**AIRWORTHINESS DIRECTIVE**

**TYPES AFFECTED:** Grob Astir CS gliders (All serial Nos.)

**SUBJECT:** Replacement of tailplane/fin locating pins.

GFA/AD 254	Issue 3
21/4/83	Sheet 2 of 3

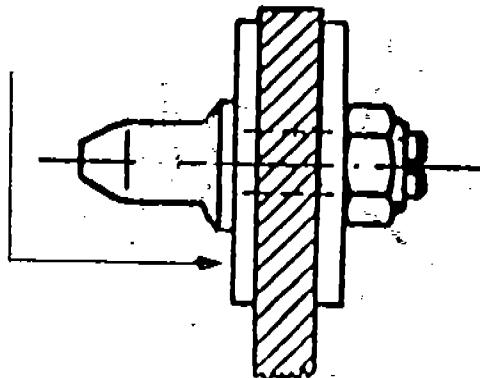
Be very sure that this side of this washer is countersunk so that the edge of its hole does not bottom on the radius at the bottom of the flange.

'New Style Pin'

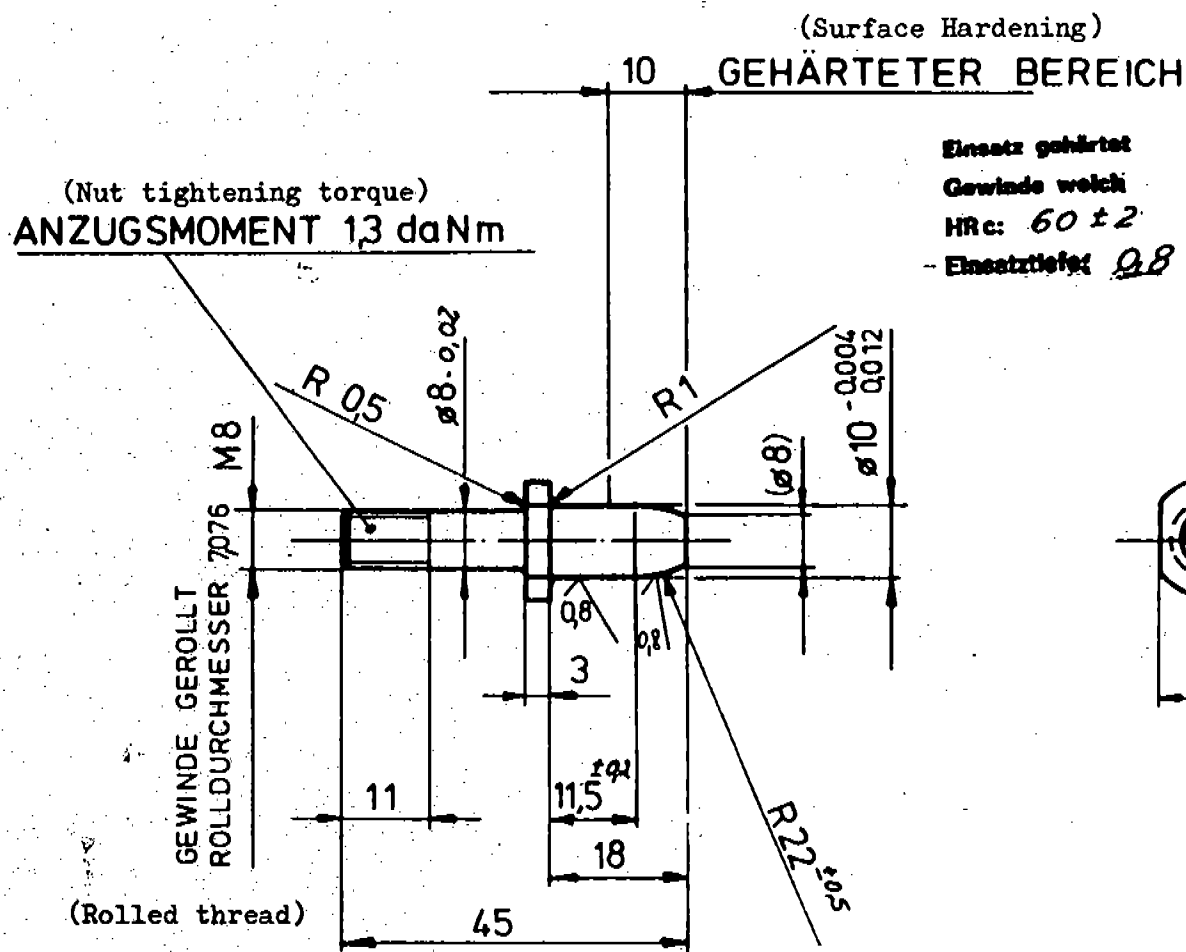
To ensure that the correct pins are fitted at all times the Grob drawing is reproduced to show the "New style" pin identifying features which are:-

- (1) Flats on the flange
- (2) Rolled thread
- (3) Only first 10mm of pin nose Nitrided
- (4) Made to Grob drawing 102-2142-32

- ACTION REQUIRED:**
- (1) All Astir CS pins are to be dye checked at 25 hour intervals irrespective of pin time in service and immediately following any heavy landing or ground loop, until replaced with Grob "new style pins".
  - (2) On receipt of "new style" pins, the old pins are to be removed and destroyed.
  - (3) "new style" pins to be fitted observing the manufacturer's recommended torque specification.  
(Shown on Dwg 102-2142-32)
